REMY | MOOSE | MANLEY
LLP

July 30, 2020

Re: Marina Coast Water District's Comments on Resolution No. 2020-13
(Exhibit 1-B) adopting the Construction of a Bypass Pipeline Modification
Addendum as Addendum 6 to the ASR EIR/EA.

ATTACHMENT 1

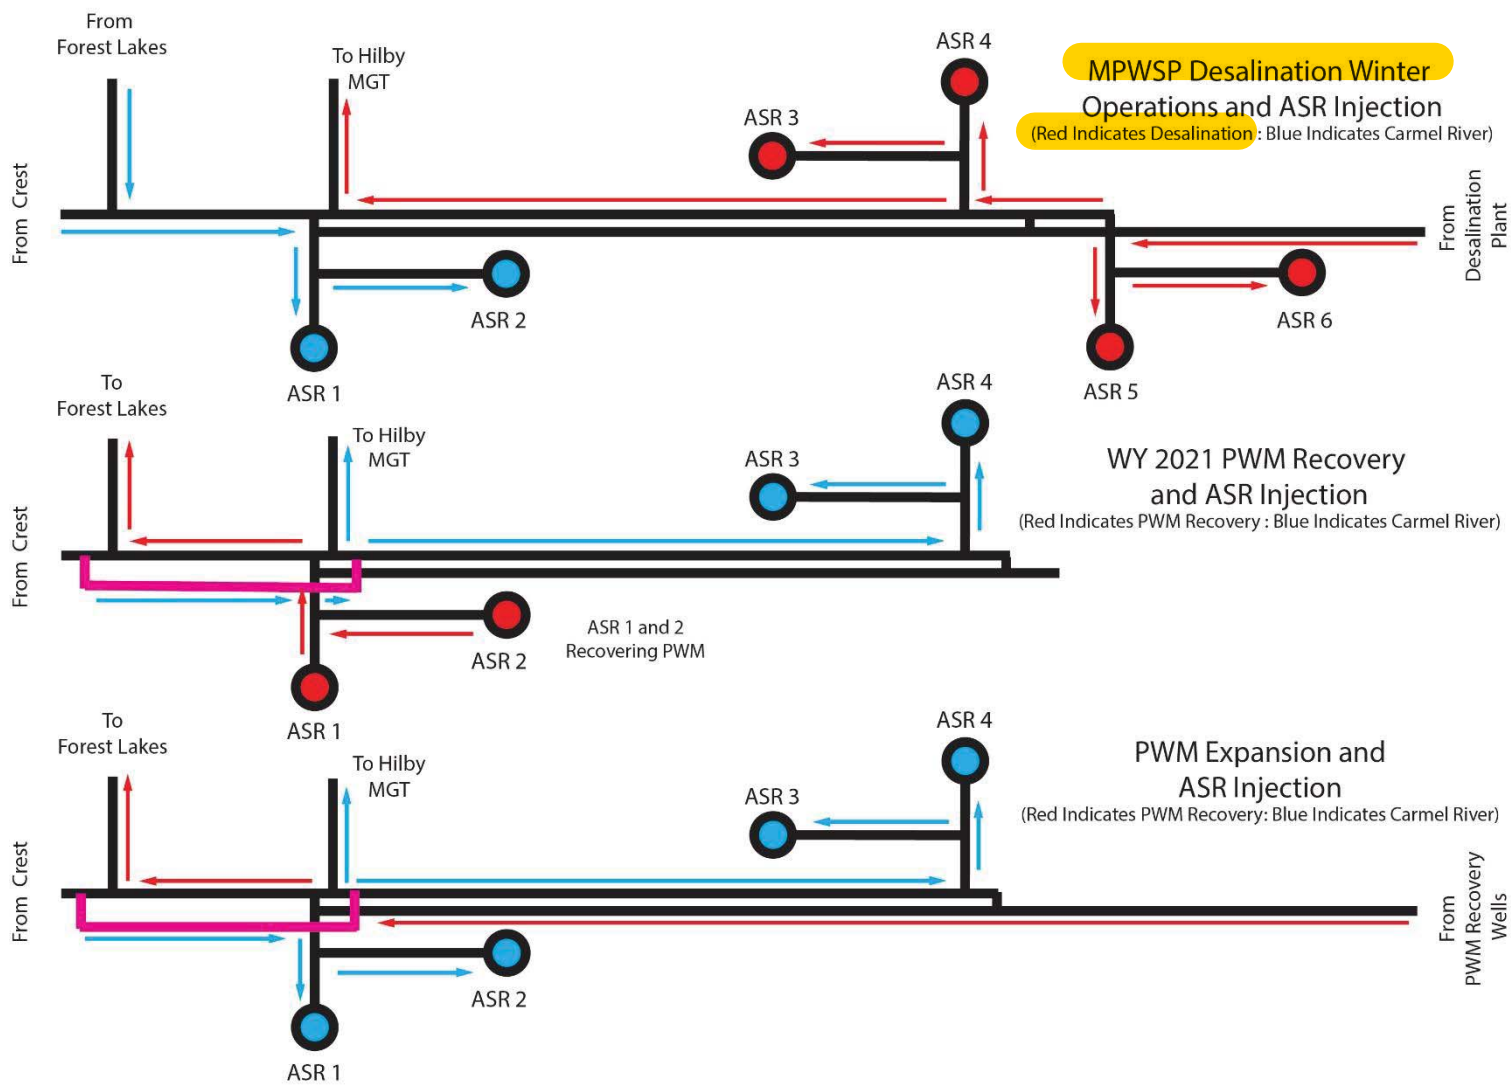
As explained in more detail below, the July 20 MPWMD Staff Presentation and Addendum reveal that the proposed bypass pipeline would connect with Cal-Am's currently useless desalination plant pipeline and that the bypass pipeline is designed and sized for the purpose of carrying "desalination" plant water – not ASR water. (See Attachments 1 and 2). Addendum No. 6 also appears to show the new pipeline would connect or interface with MCWD's potable water pipeline in General Jim Moore Blvd., which raises multiple logistical and environmental concerns that are not addressed in the Addendum or other communications with MCWD. Therefore, MCWD requests the Board delay consideration of Addendum No. 6 to allow your staff time to meaningfully consult with MCWD on these issues and those discussed below.

B. The proposed bypass pipeline must be analyzed as part of the MPWSP; the pipeline would connect with Cal-Am's currently useless desalination plant pipeline; it is designed and sized to carry "desalination" plant water – not ASR water.

As we noted in our prior comments, if Cal-Am wants to inject and extract ASR water simultaneously, it must explain the deficiencies in its system to justify the need for the bypass pipeline. Cal-Am has not. Nor have they responded to MCWD's questions on this issue. Based on MCWD's review of the Addendum and available documentation, it does not appear that the bypass pipeline would ever be needed to deliver ASR water. Rather, it appears Cal-Am has identified a constraint for using ASR pumps to deliver
